SUBJECT: Forwards F series potential finding repts issued by GA Co.
 Repts have not been verified for validity & accuracy by
 original design organization.

Subject: Docket 50-361 and 50-362
San Onofre Nuclear Generating Station
Units 2 and 3

Enclosed are sixty-three copies, each, of "F" series Potential Finding Reports issued by General Atomic Company, as follows:

BMC. 23259 ON S2-S1-043-H-020 @ PLAN EL. 57'-2 3/4"

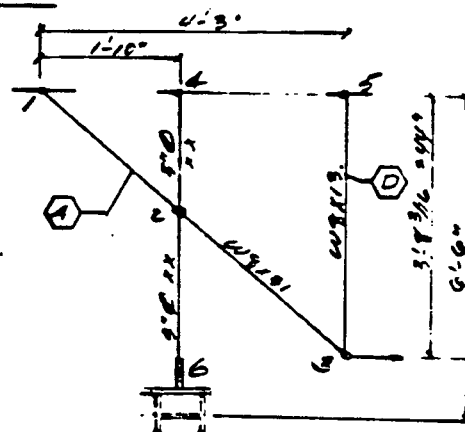
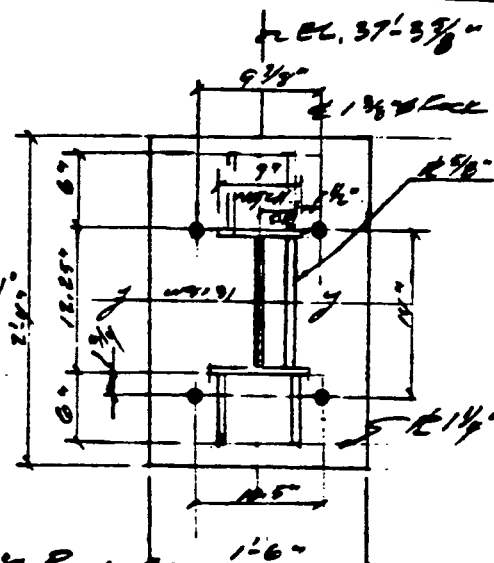
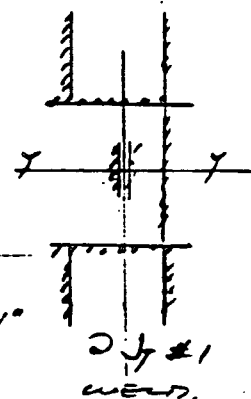
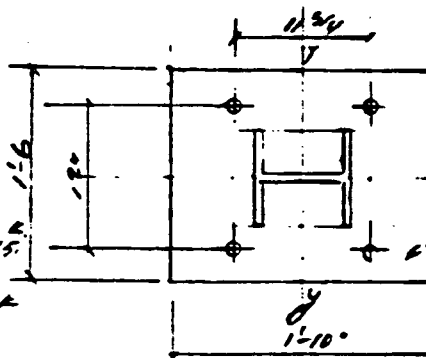
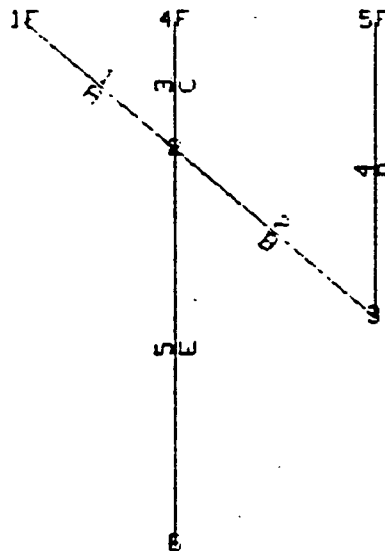
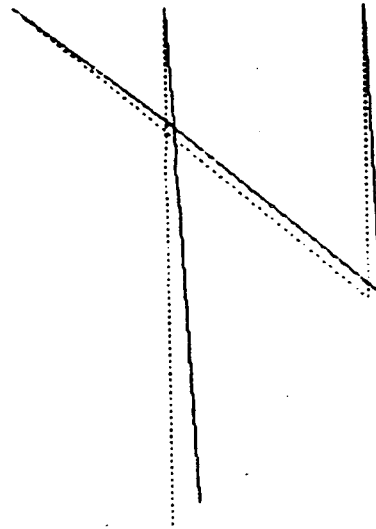
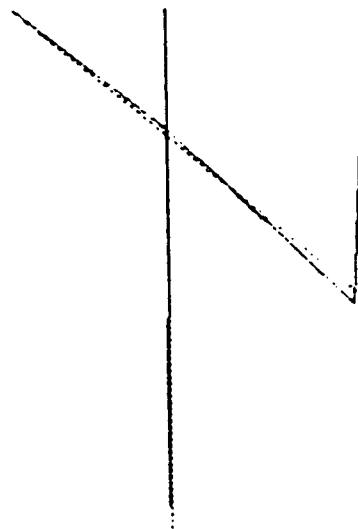
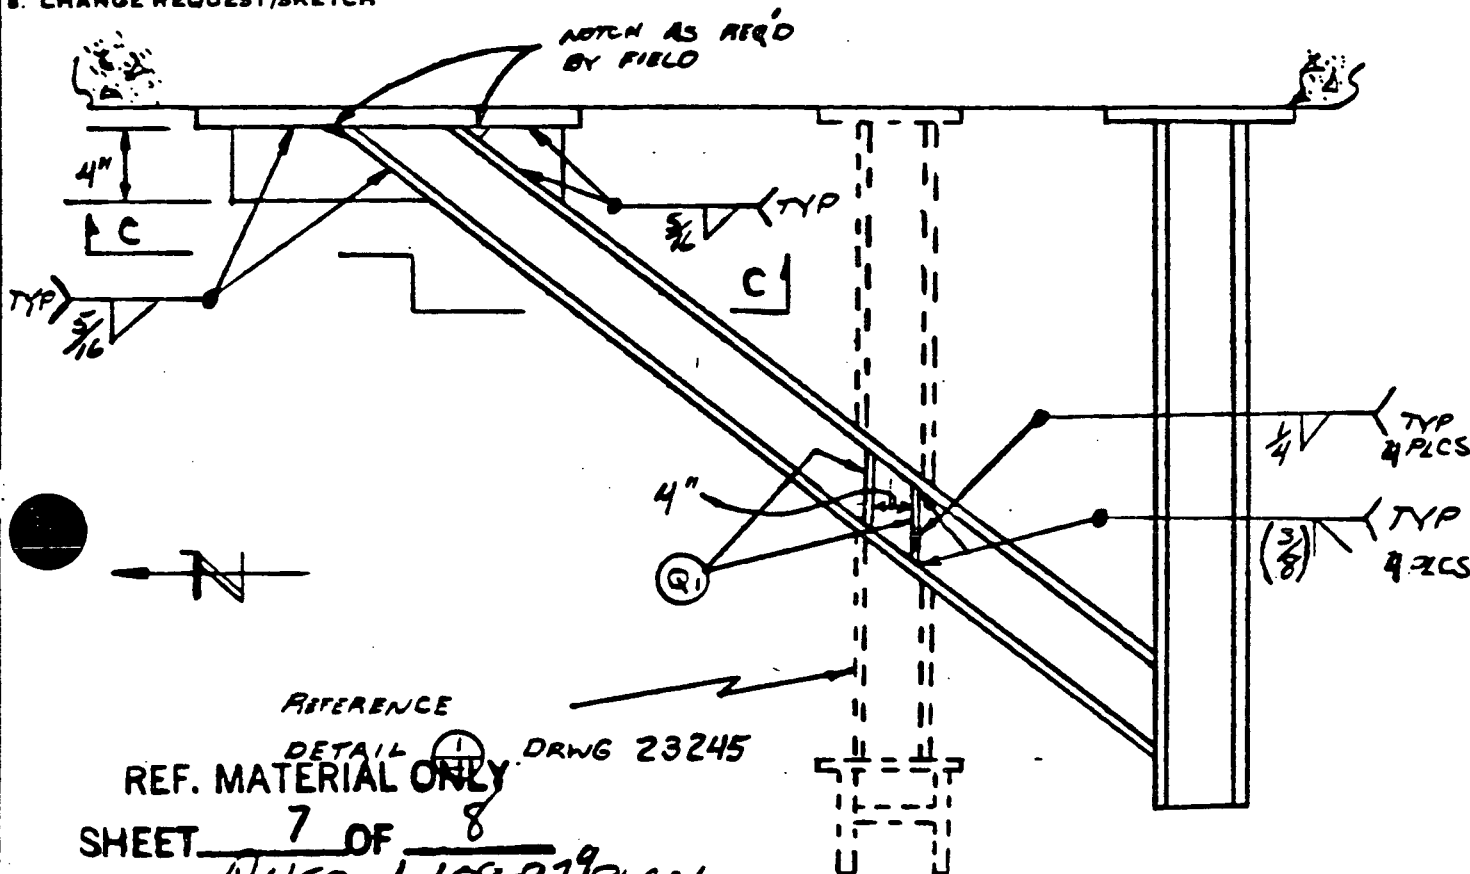
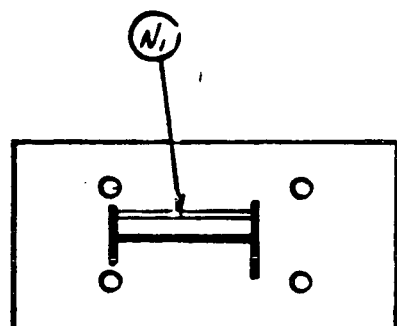
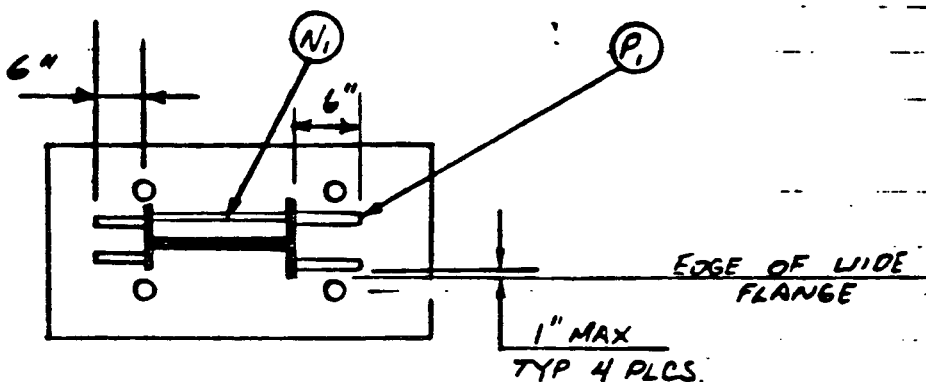
Changes shown in DCN Sub No. 07 and 08, S-7295 and S-7450 dated 1/23/81 and 2/5/81 are not included in calculation report: TAG:S2-S1-043-H-020, P450-150-169 dated 4-10-80. This change modified the support to interface with jet impingement bracing. There is no indication that loads imposed by jet impingement bracing have been evaluated or compared with loads used in original calculations.

Cable Tray Hanger Drawing #37185, Rev. 2

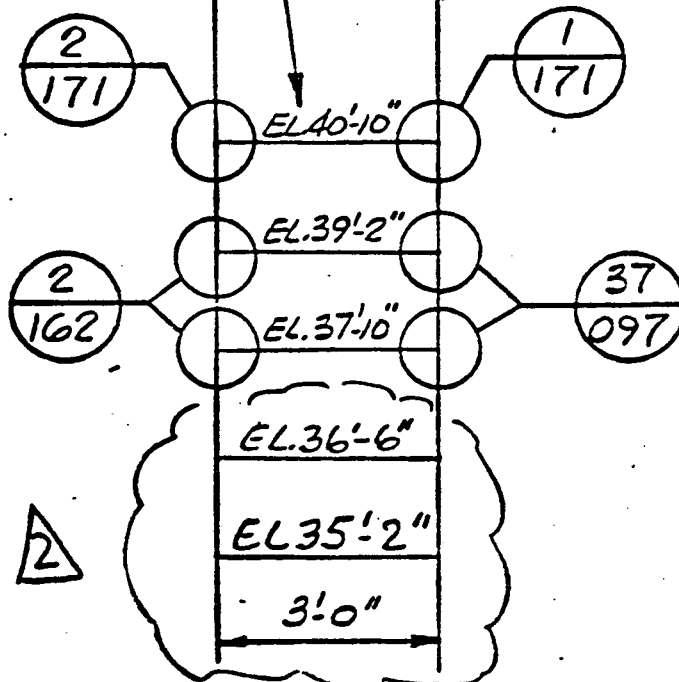
Drawing #37185, Rev. 2, (Attached) is an unauthorized revision signed by the draftman only, with no issue date, thereby indicating a drawing control violation. The drawing control log shows the last revision of this drawing to be Rev. 1.

A review of the drawing and a walkdown at the jobsite demonstrated that the cited Division 2 to 37185 was never issued nor implemented at the jobsite.

The drawing was inadvertently included in the package sent to you in the incomplete state. This condition has now been corrected.

SIGNATURE Steven Groom DATE 10-25-76 CHECKED W. B. B. B. DATE 12-26-76
 SUBJECT SONGS 2+3 JOB NO. 10079-003
 SUBJECT SEISMIC CLASS I CABLE TRAY SUPPORTS SHEET 427e OF 574 SHEETS

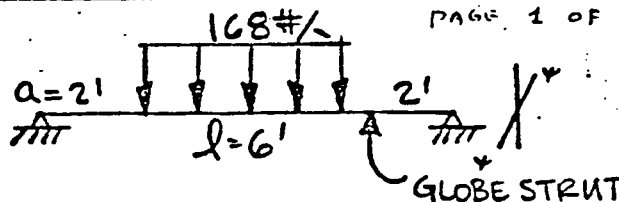
Only E' was considered for the vertical loads on p. 427 of Bechtel Cal C270-01-02. Loads of $D + L$ were neglected in the calculation. Please see Attachment No. 1 (Bechtel Cal C270-01-02 Sheets: 427e-427f) for details. On page 427f the equation for f_{bx} contains the factor of 1.5 which represents only the seismic load E' as shown on page 427e for the value of S_v . The correct value should be 2.5 to account for $D+L+E'$.

This calculation will be revised to document the inclusion of dead loads.
